04V-350
(12 pages)

Affected vehicles are all 1999-2004 VZ800 motorcycles certified to California emission standards ("California-specification VZ800 motorcycles"). California-specification VZ800 motorcycles are equipped with an evaporative emission control system. This system is not equipped on VZ800 motorcycles that are not certified to California emission standards.

Subject : Recall Campaign for Canister and Evaporative system on VZ800 E33 spec.

ILLUSTRATION #1

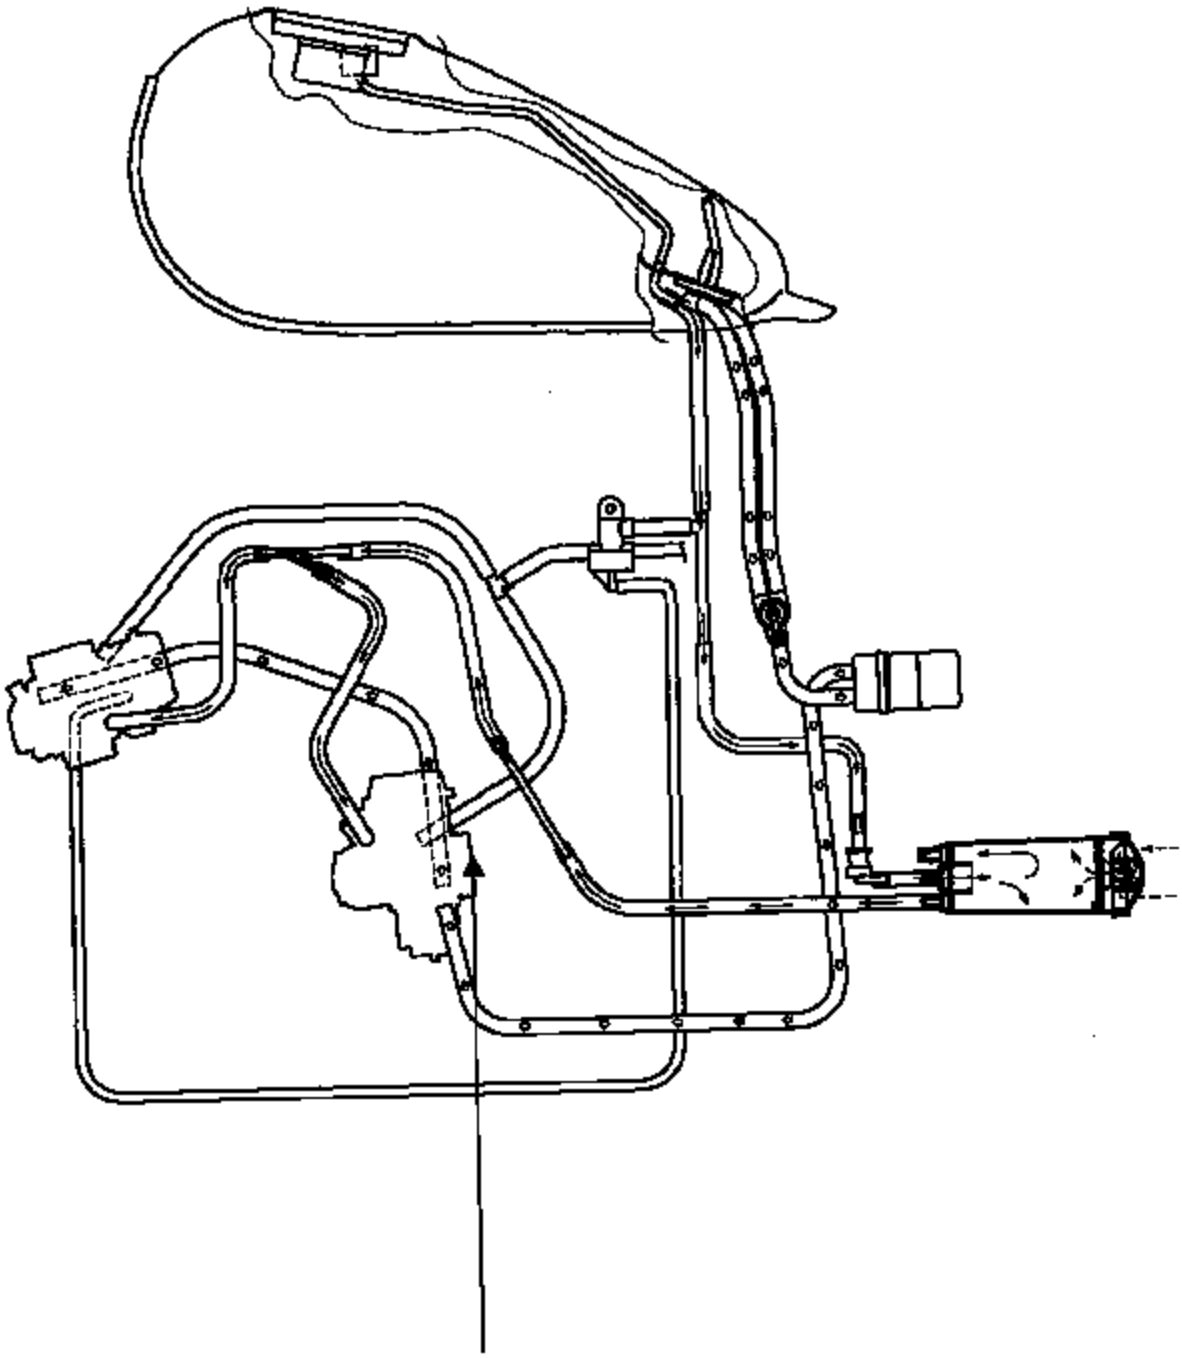
Illustration #1 shows the layout of the California-specification VZ800 evaporative emission control system. When a subject motorcycle is parked after city driving in heavy traffic, under some conditions elevated pressure in the fuel tank vent line due to restricted flow through the carbon canister, can cause backpressure in the carburetor vent lines through the surge control valve. Due to the orientation of the rear carburetor, this can on some occasions cause liquid fuel from the rear carburetor float bowl to overflow into the rear carburetor air filter box. In the presence of an ignition source, this fuel can cause a fire.

Suzuki will conduct a safety-related recall to correct the defect in affected motorcycles. The carbon canister on affected motorcycles will be replaced with a new-design canister and associated vent line changes will be made. The new canister has reduced backpressure due to a revised structure and an additional port for separate routing of fuel tank vapors and carburetor vapors to the carbon canister. Illustration #2 (attached) shows the layout of the new evaporative emission control system. The vacuum hose routing diagram on affected motorcycles will also be updated to show the new system design.
